## DOCUMENT CHANGE REQUEST

DCR number	568	Changes required for:	General	Originator:	Steve Thacker - ESCC
Date:	2010/01/12	Date sent:	2010/01/12	Organisation:	
Status:	IMPLEMENTED

Title: Generic Specification for Discrete Semiconductor Components

Number: 5000 Issue: 5

Chart F4

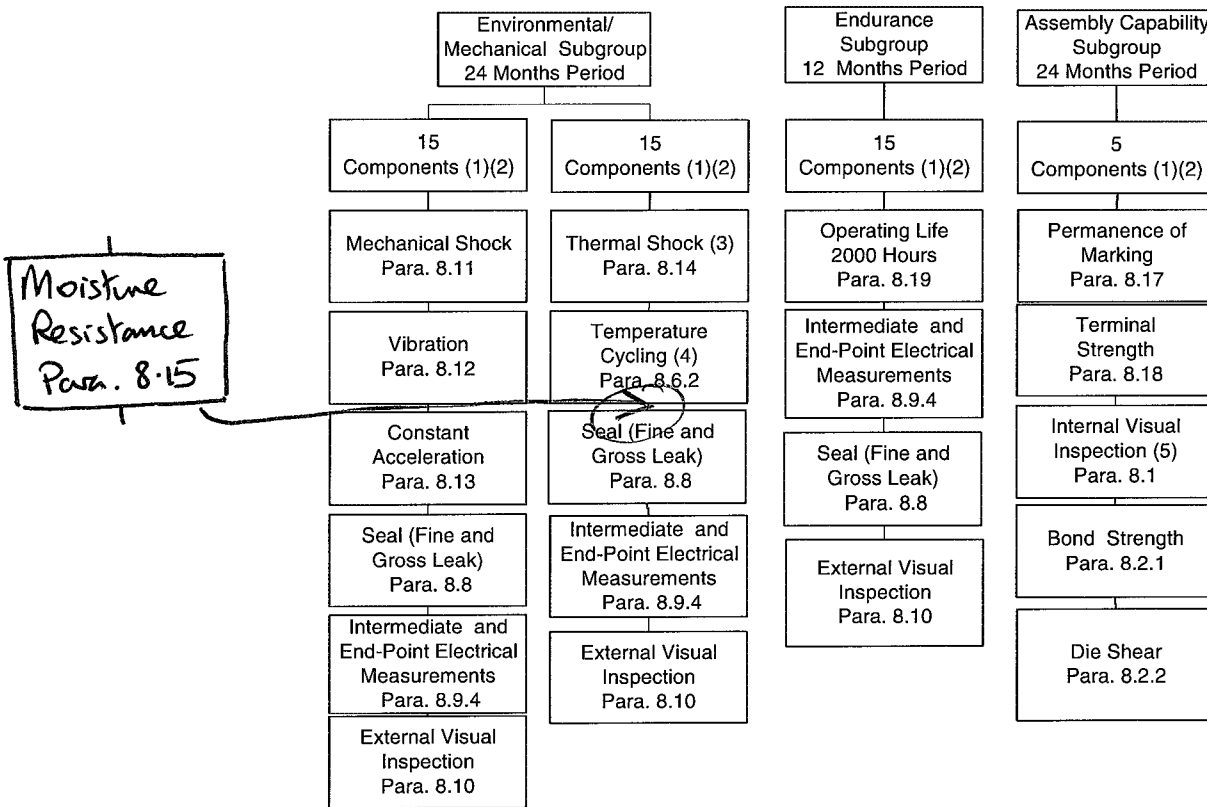
Add missing test box for Moisture Resistance, as follows (see attached mark-up), in The Environmental/Mechanical Subgroup (2nd column) between Temperature Cycling and Seal

-----  
Moisture  
Resistance  
Para. 8.15  
-----

This is an editorial error. The Moisture resistance test box in Chart F4 was wrongly removed during implementation of DCR399 on 5000 issue 3.
